RESPONSE TO BRISBANE CITY COUNCIL FURTHER ADVICE LETTER

DEVELOPMENT PERMIT FOR MATERIAL CHANGE OF USE FOR MULTIPLE DWELLING OVER LAND AT 63 – 69 MELTON ROAD, NUNDAH (LOT 2 ON RP121656 & LOT 19 – 20 ON RP33945).

COUNCIL REFERENCE: A006988485

Figure 1: Section – gradient of shared pathway and driveway.

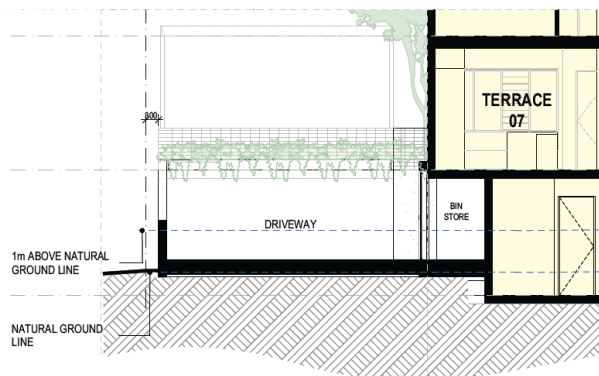
The submitted plans (including Drawing SD109 and associated sections) have been assessed, and it is identified that annotated level discrepancies between these elements, resulting in:

- a. *A vertical step (up to approximately 300mm) between the shared access area and driveway;*
- b. *Creation of a hazard for pedestrian movement and bin handling;*
- c. *Inability to achieve the demonstrated swept path performance for refuse collection vehicles (RCVs); and*
- d. *Reduction in effective trafficable driveway width.*

Provide amended plans (including sections and AHD spot levels) demonstrating that the refuse storage area, adjacent access pathway, and internal driveway are designed at consistent and compatible grades to ensure safe and functional operation for both pedestrian and refuse bin movements.

Amended plans must demonstrate a coordinated and functional design outcome that does not compromise either refuse servicing or driveway operation, including consistency across all submitted drawings in accordance with PO19 of the Transport, Access, Parking and Servicing code, PO32 of the Multiple dwelling code, and PO8 of the Infrastructure design code.

In response to **Item 1** of Council's Further Advice, the Applicant confirms that the shared pedestrian pathway provides a gradient consistent and compatible with the driveway. Refer to **Figure 1** below.

Figure 2: Revised swept path for RCV manoeuvring.

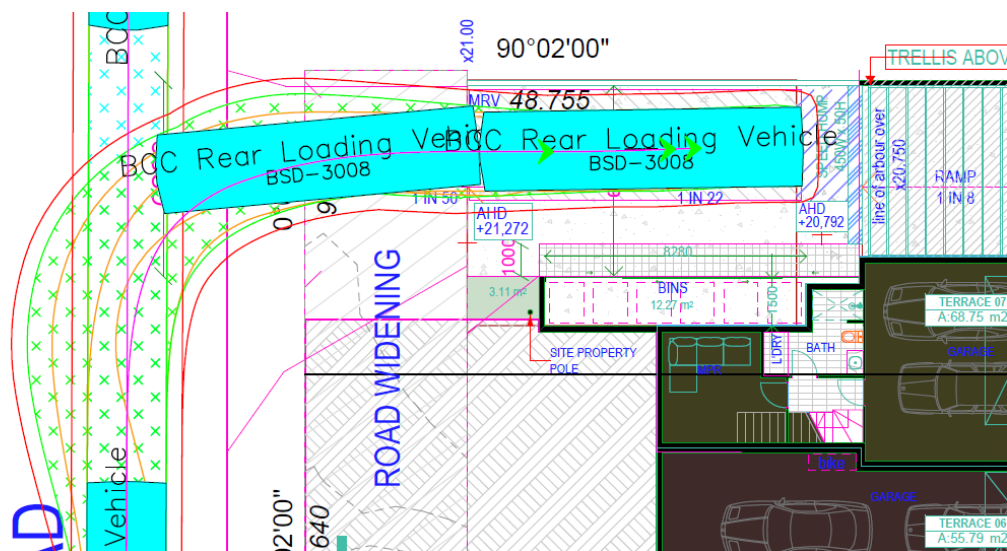
The current documentation demonstrates that proposed landscaping encroaches into the required swept path for RCV manoeuvring.

- Remove the landscaping within the swept path envelope; or
- Limit landscaping to low ground cover that does not exceed 150mm in height and does not obstruct vehicle movement.

Provide revised swept path analysis and landscape plans that resolve the identified conflict along the northern edge of the internal driveway.

All plans must be consistent and clearly demonstrate unobstructed vehicle manoeuvrability in accordance with PO19 of the Transport, Access, Parking and Servicing code and PO32 of the Multiple dwelling code.

In response to **Item 2** of Council's Further Advice, the landscape strip adjacent to the driveway has been removed. As outlined in **Figure 2** below, the removal of the landscape strip ensures that no conflicts with the RCV manoeuvring occurs.

Figure 4: Revised Retaining Wall Outcome (retaining wall outlined in red)

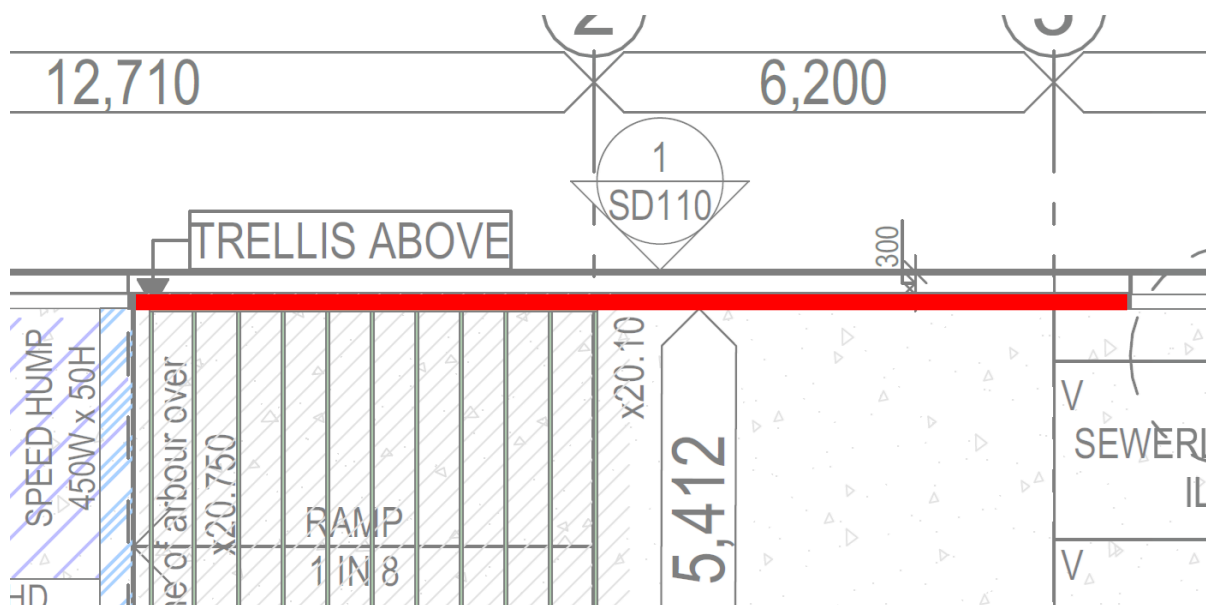
The revised civil drawings still show a retaining wall in cut against the northern property boundary without an appropriate offset to allow for construction and the installation of subsoil drainage within the property.

- Provide detailed design documentation and supporting commentary demonstrating how the proposed retaining wall located in cut along the adjoining property boundary will be constructed without encroachment onto, or impact to, the neighbouring property.
- Alternatively, revise the design to setback the retaining wall a minimum of 300mm from the boundary to allow for construction access and subsoil drainage.

Details must include construction methodology, maintenance considerations, and drainage provisions in accordance with PO2 of the Filling and excavation code.

In response to **Item 5** of Council's Further Advice, the retaining wall along the northern boundary has been setback 300mm off the northern side boundary. Refer to **Figure 4** below.
